POST CONSTRUCTION ROAD SAFETY AUDIT
Central Motorway Junction Cycleway
AECOM Component

Prepared for NZTA

10 March 2015

Figure 3: Note close proximity of motorway, potentially non-compliant barrier system and potential for fallen objects to strike path users

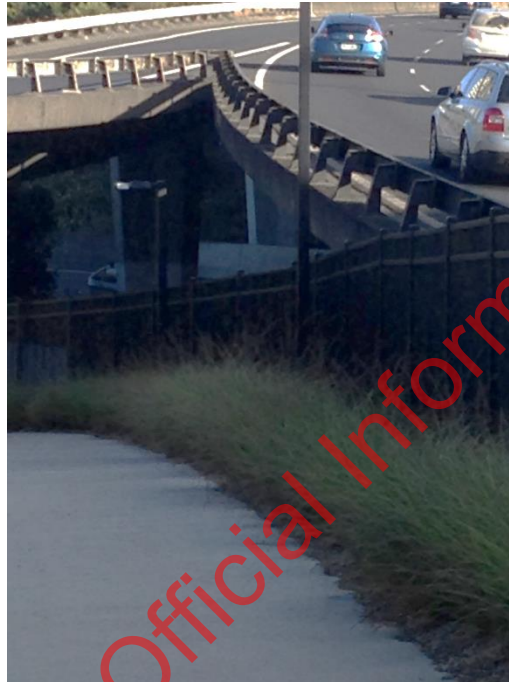
At the Symonds Street motorway onramp connection with the southern motorway the shared path descends from a level above the motorway lanes to travel underneath the onramp. At this location the nearest lane of the southern motorway is no more than 2 m away (at head height). The SAT was concerned that any debris (accidental or deliberate) from a passing vehicle would enter the shared path area at roughly head height, posing a significant hazard to a passing cyclist or pedestrian. This hazard is further exacerbated given the low non-solid side barrier at this location. The SAT was also concerned that the current barrier would not comply with NZTA's current requirements for side road protection and may not contain a heavy vehicle impact.

1. Review whether the motorway side barrier is fit for purpose
2. Provide a screen to stop debris falling (or thrown) from motorway traffic from entering the shared path area

Frequency	Severity	Rating
Crashes are likely to be infrequent	Death or serious injury is likely	The safety concern is moderate
Designer response	<ol style="list-style-type: none"> 1. Motorway side barrier is not in project scope. This concern should be referred to AMA for consideration to upgrade the bridge and edge protection. 2. This issue has been raised before in previous RSA's and the risk is no different to debris falling off a truck further down the cycleway where it is located alongside the motorway or street (eg. Beach Rd section). 	
Safety engineer comment	ADR. This issue will be considered in an area wide investigation of barrier fitness.	
Client decision	Investigate the two SAR recommendations above	
Action taken	AMA to take care of recommendation 1; the screen to catch debris falling to cyclists

is under design for impenatation.

Figure 5: Streetlight not working

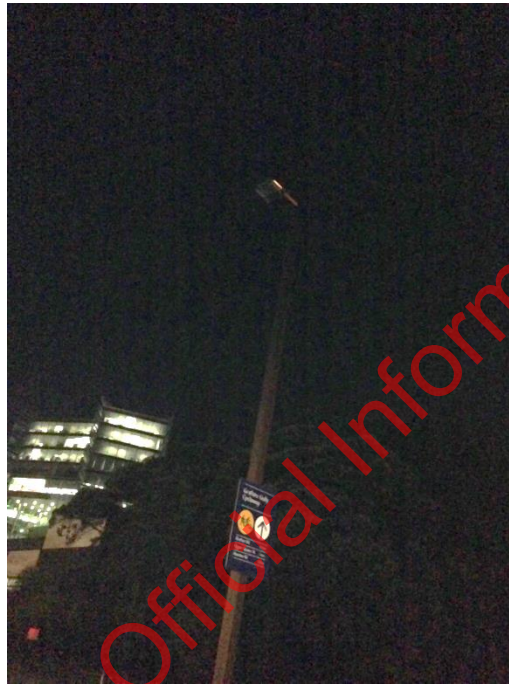
During the night inspection the SAT noted that half the streetlights on Stage 1 were not working (9 lights). On previous site visits to this stage this has also been the case, whereas the lighting on all other stages was 100% operational. Poor lighting is a possible risk to personal security and increases the chance of crashes between path users.

Undertake a thorough maintenance check of the lighting in Stage 1.

Frequency	Severity	Rating
Crashes are likely to be infrequent	Death or serious injury is unlikely	The safety concern is minor
Designer response	NZTA (AT) maintenance need to raise this fault with Vector Ltd as the supplier of power to the AT street lighting or advise Council Action line of the fault to resolve this issue. All lights were working at the time of handover from the Contractor and at end of defects period.	
Safety engineer comment	ADR. This is a maintenance issue.	
Client decision	NZTA to inform AT of the lighting maintenance issue which is now their responsibility	
Action taken	AT has taken responsibility of the lighting maintenance. No further action to be taken.
